Addendum

PROJECT: Board of Commissioners for
Miami County, Ohio
Miami County One Stop Center

ADDENDUM NO. 2

SHEET NO.
S3.1

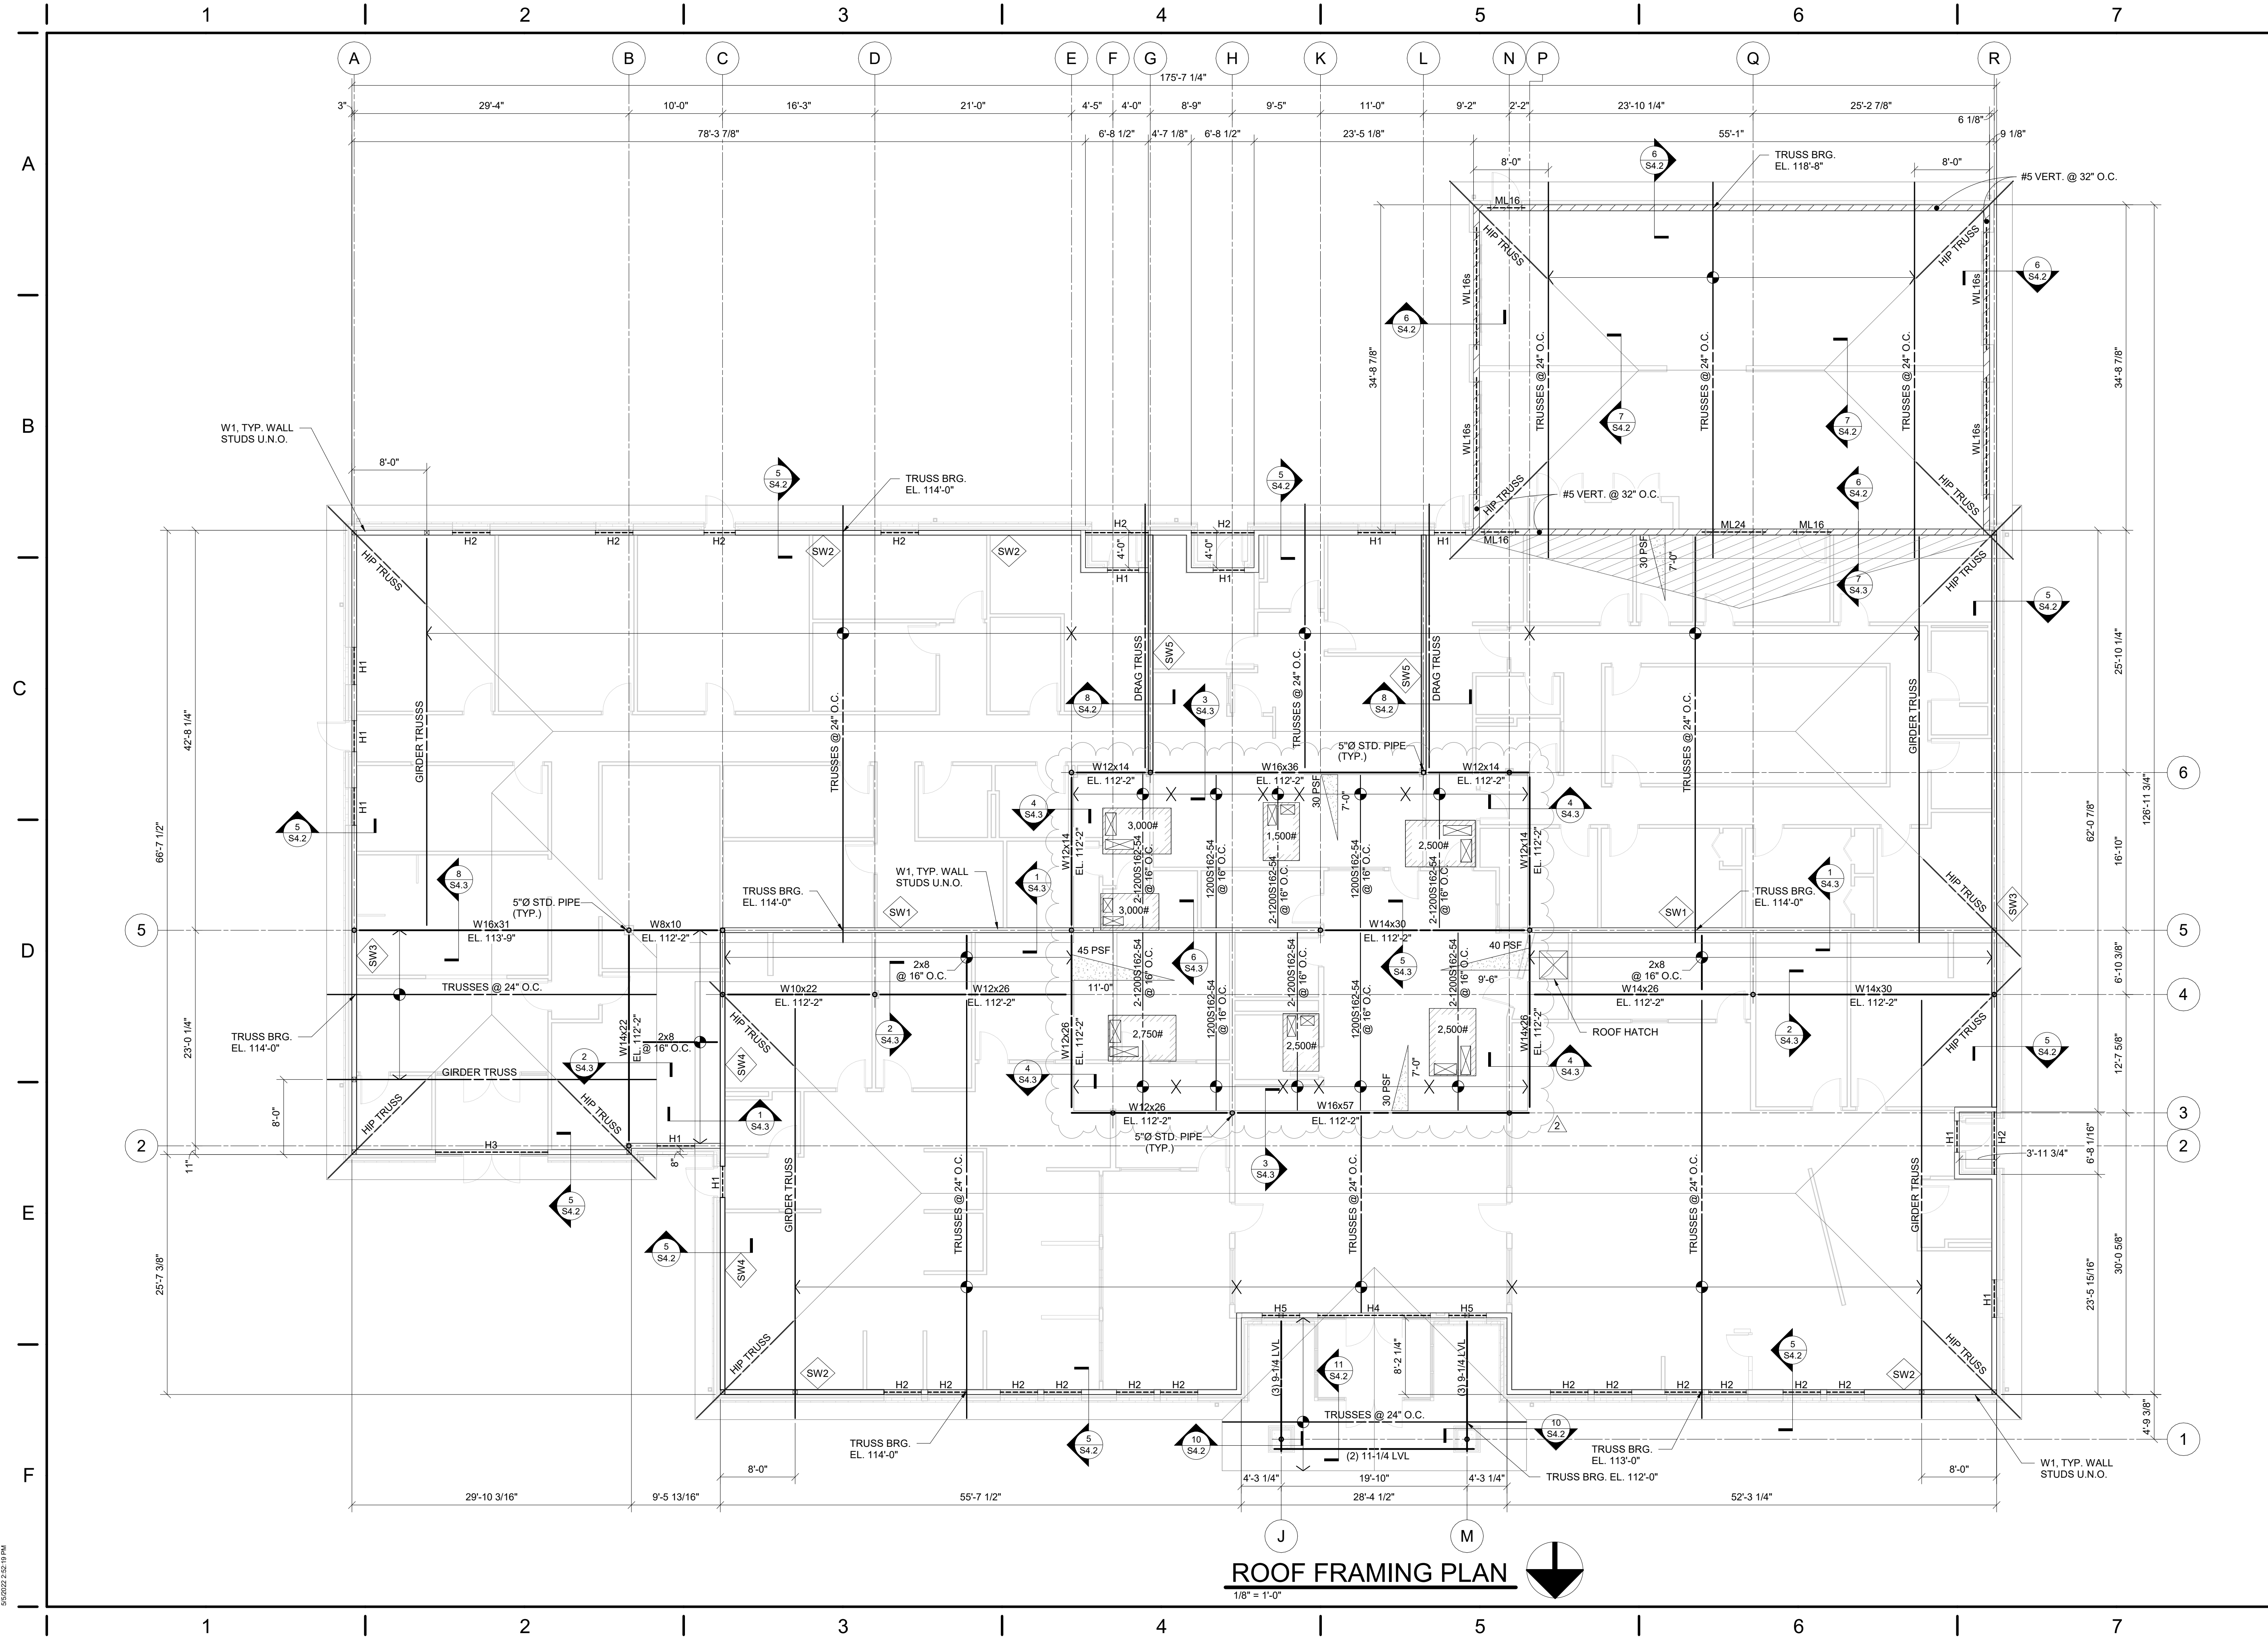
ITEM S1 SHEET NO. S3.1 ROOF FRAMING PLAN

Revised I-joint framing in center well to cold-formed metal framing.

SHEET NO.
S4.3

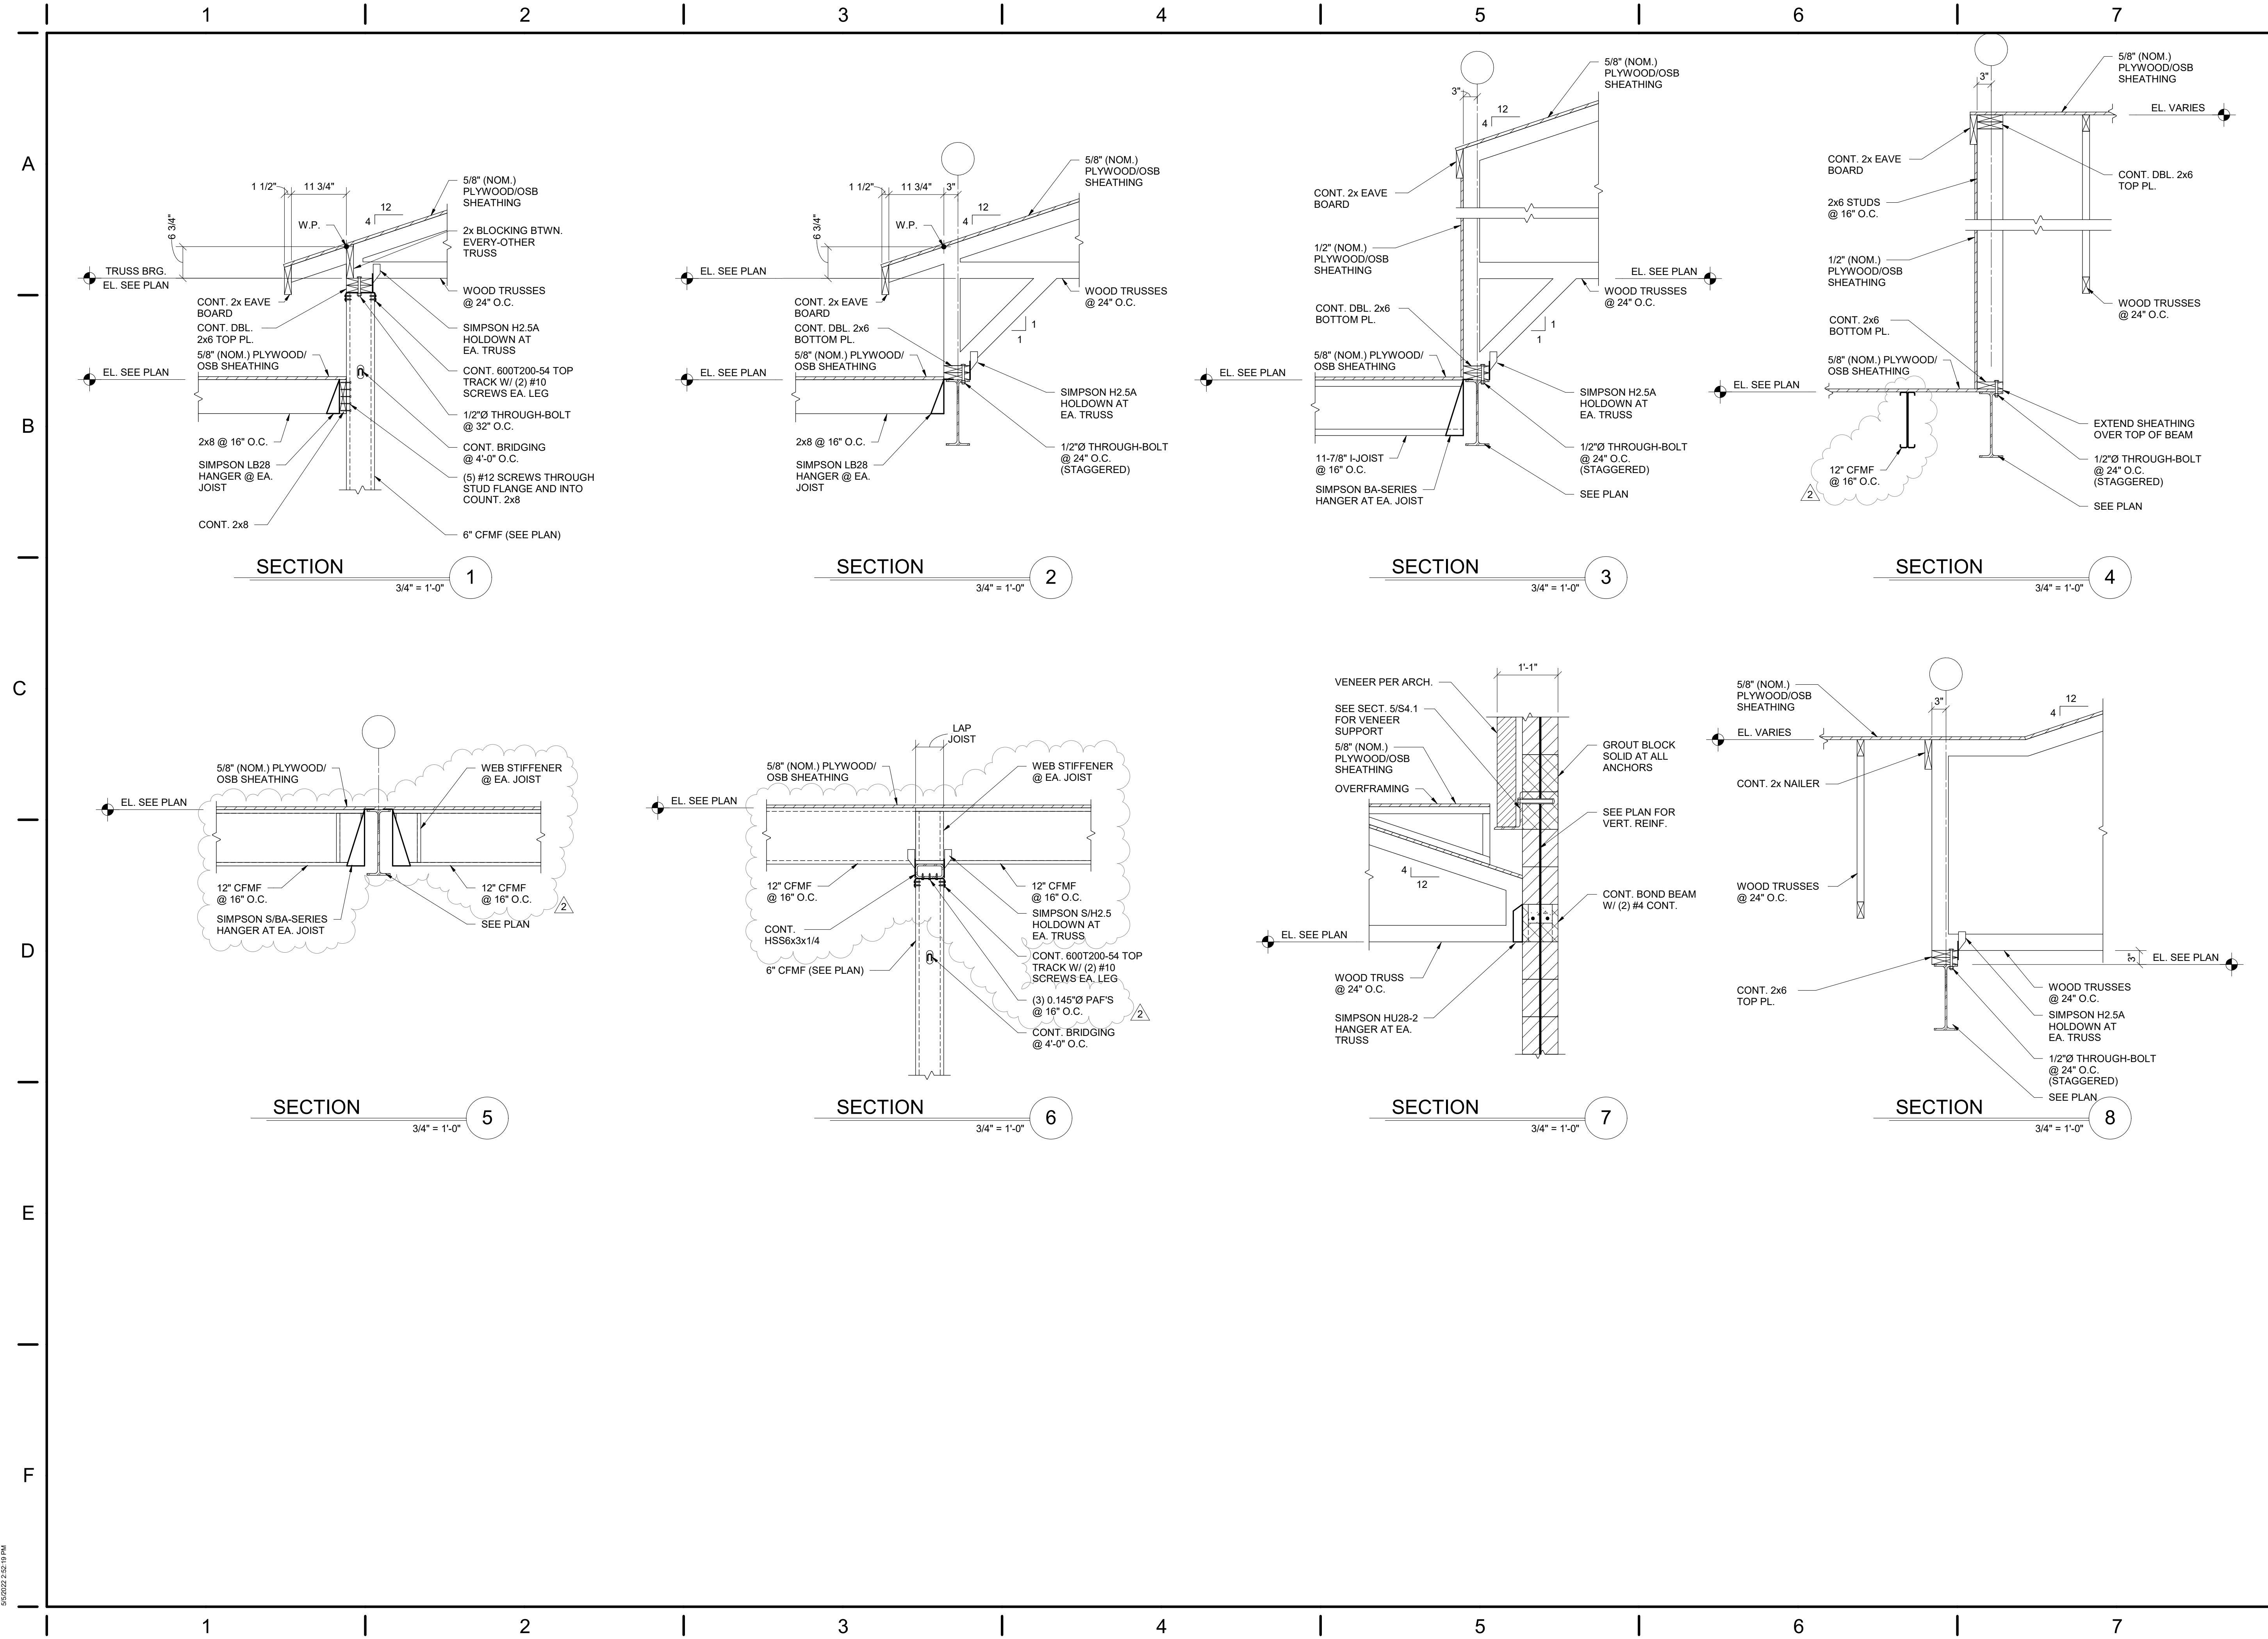
ITEM S2 SHEET NO. S4.3 FRAMING DETAILS

Revised I-joint framing in Sections 4 and 6 to cold-formed metal framing.
